REQUEST FOR CERTIFICATE OF APPROPRIATENESS

MPC File No.: 26-004408-COA

Address: 123 East Henry Street

Staff Report - Certificate of Appropriateness

The images below are undated but show mid to late 20th century alterations to the building, including a black and white HABS photo, also undated but with a note that it was taken after 1933.

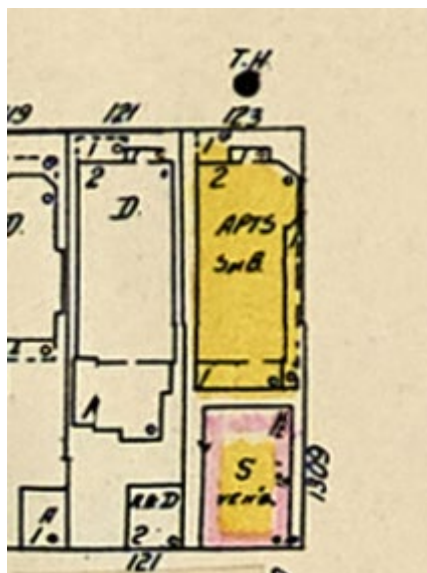
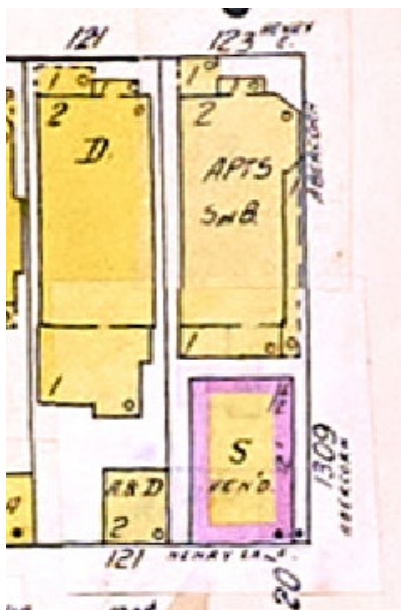
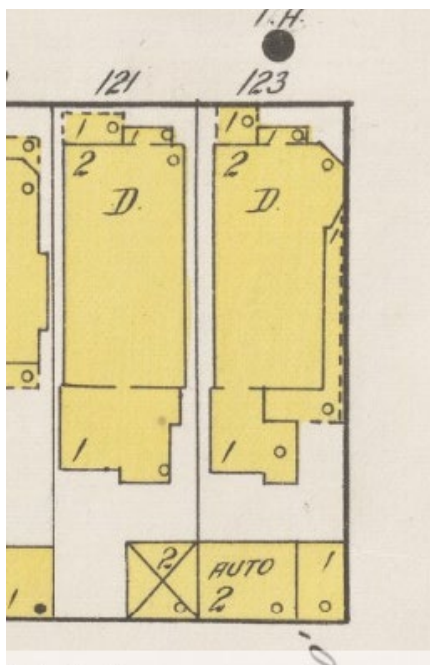
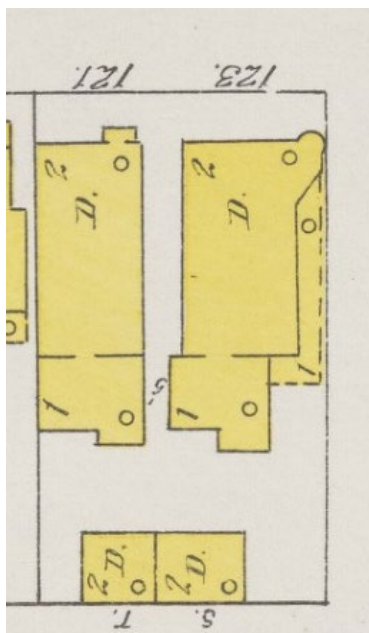
The applicant intends to meet this standard. Staff requests more information about items such as each window, differentiating which ones can be repaired versus which windows may require a full replacement. The side porch seen in the historic photo is noted to still exist beneath the Permastone and will be reopened. Staff requests elevation drawings showing the final result and inclusion of photos that detail the current conditions and what windows may still exist on the now-interior wall that was once an exterior wall facing Abercorn Street, as well as the ornamental wood detailing on the porch.

Staff requests information on how the existing foundation will be handled when the side porch is restored and whether it will return to the lattice infill seen in the photo or if new wood boards will be placed between the piers as it currently exists.

The applicant notes that the historic side porch seen in the photo still exists beneath the PermaStone infill and there is an intent to reopen it. Staff requests information including photos of existing conditions, as well as whether the decorative woodwork is also still intact or if it will be recreated, as well as elevation drawings showing the end result of the proposed work.

- 1. Provide elevation drawings to show the end result of the proposed rehabilitations, including the side porch restoration, window and door configurations, and siding details.**
- 2. Provide a window inventory detailing each elevation's windows, noting which ones are to be repaired versus proposed for replacement. This should also show the two fire escape doors that are proposed to be returned to window openings.**
- 3. Provide photos of the current conditions of the side porch and include details about whether there are still openings on the now-interior wall facing Abercorn Street, and how it will be handled when the porch is uncovered.**
